ROGERS LABS, INC.

RE: Response for reference number 19311.

Equipment: FCC ID: HN21555-2450
FCC Rules: Part 2 and 15.247

FCC Response letter for request number 19311.

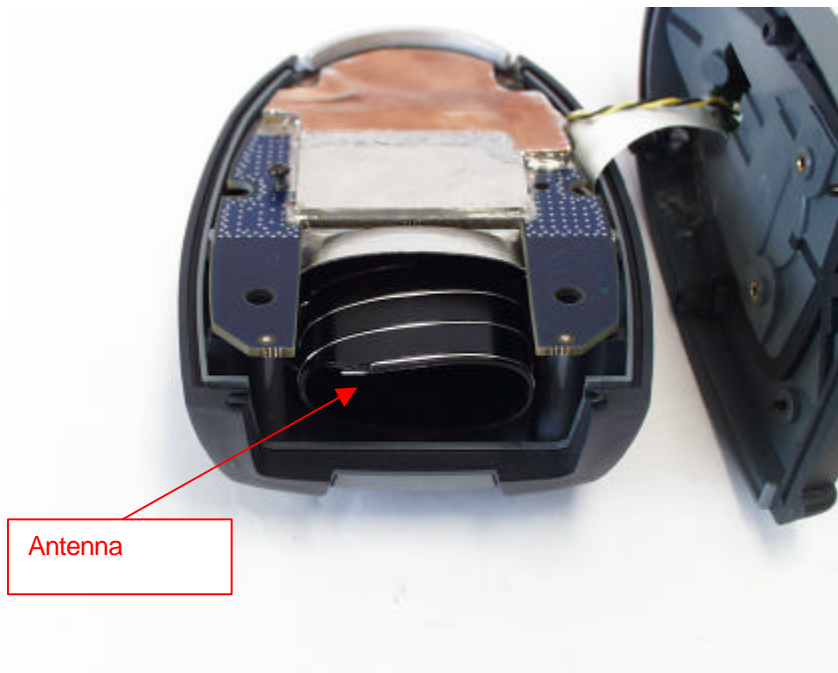
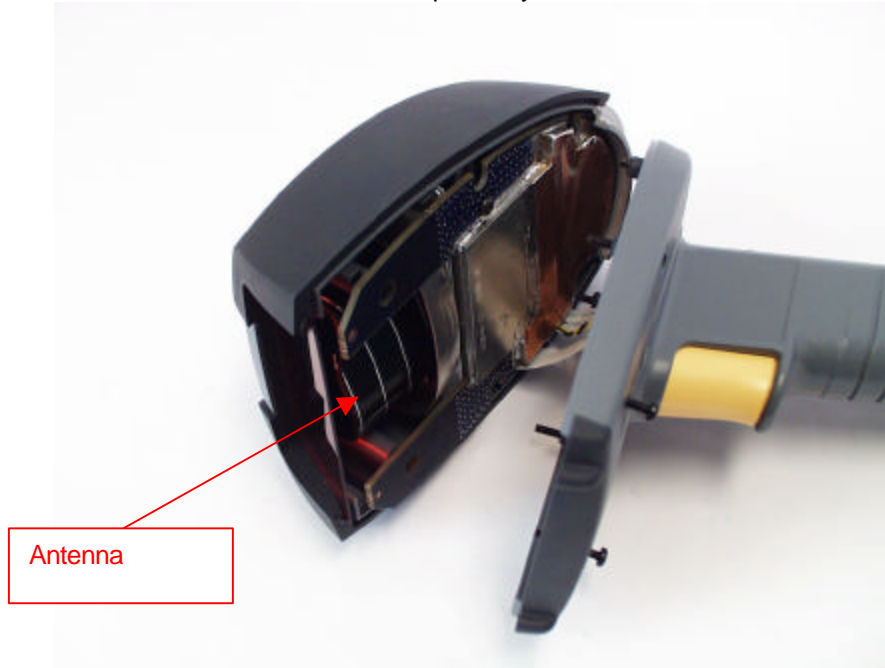
1) Need to have a photo or illustration showing where is the antenna located in this device to determine if the hand SAR is done appropriately.

2) It appears the handle has been taken off from the device in the revised hand SAR photos.

1. Here is a photograph of the unit with the handle removed. Notice the maximum antenna radiation pattern is out the front of the unit. The handle provides an easy to hold location for the user and restricts the proximity of the users hand to the antenna.

2. The handle was removed in the original SAR testing exactly like was done for the 1555-900 unit, which you approved 1/26/2001 refer to the SAR report for FCC ID HN21555-900. This was done to yield the maximum radiation exposure for "touching the surface of the antenna". There are no electronics in the handle which would effect the SAR data.
